Access Compliance Report

Public Rights-of-Way

(Curb Ramps)

Intersection ID: 4791	Main Street: STONEFIELD_DR	Cross Street: TUCKER_CT	Location:	W
ADA ID: 6EA6EE257C47	Ramp Type: Perp	Initial Pass/Fail: Fail	Overall Compliance: No	Severity Score: 37.5
Codes/Mitigation Info/Possible Solution		Field Measurements/Component Compliance

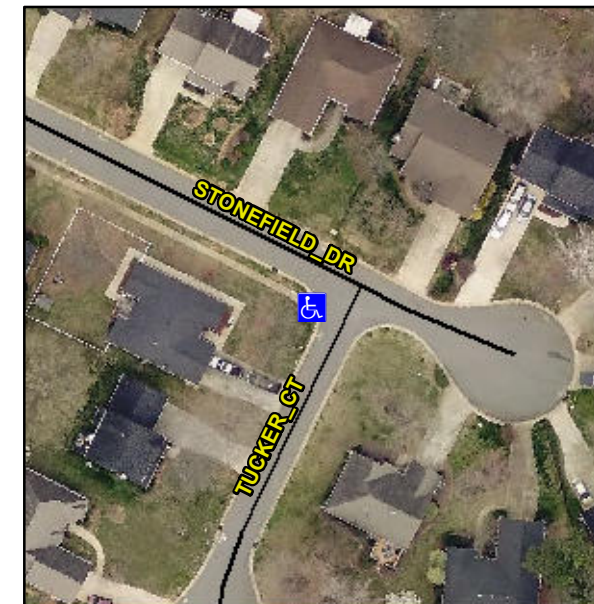
Not Found, R304.2.2, R304.5.3

Compliance	Description	Data	Compliance	Description	Data
N/A	Ramp Length (in)	94.0	No	Ramp Slope (%)	18.2
Yes	Ramp Width (in)	64.0	No	Ramp XSlope (%)	6.5
N/A	Flare Type LT	N/A	N/A	Flare Type RT	N/A
N/A	Flare Slope LT (%)	N/A	N/A	Flare Slope RT (%)	N/A
N/A	Flare Traversable LT?	N/A	N/A	Flare Traversable RT?	N/A
N/A	Landing Length (in)	N/A	N/A	DWS Provided?	N/A
N/A	Landing Width (in)	N/A	N/A	DWS Contrast?	N/A
N/A	Landing Slope (%)	N/A	N/A	DWS Length (in)	N/A
N/A	Landing X Slope (%)	N/A	N/A	DWS Full Width?	N/A
N/A	Landing Curb? (Y/N)	N/A	N/A	DWS Offset (in)	N/A
N/A	Shared Landing?	N/A			
N/A	Gutter Ponding?	N/A	N/A	Gutter Slope (%)	N/A
N/A	Gutter Lip Ht (in)	N/A	N/A	Gutter X Slope (%)	N/A
N/A	Painted X Walk1?	No	N/A	Painted X Walk2?	N/A
	X Walk 1 Direction	To SE		X Walk 2 Direction	N/A
N/A	X Walk 1 Width (in)	N/A	N/A	X Walk 2 Width (in)	N/A
	X Walk 1 Slope (%)	3.3		X Walk 2 Slope (%)	N/A
	X Walk 1 X Slope (%)	1.9		X Walk 2 X Slope (%)	N/A

Remove & Replace Entire Ramp.
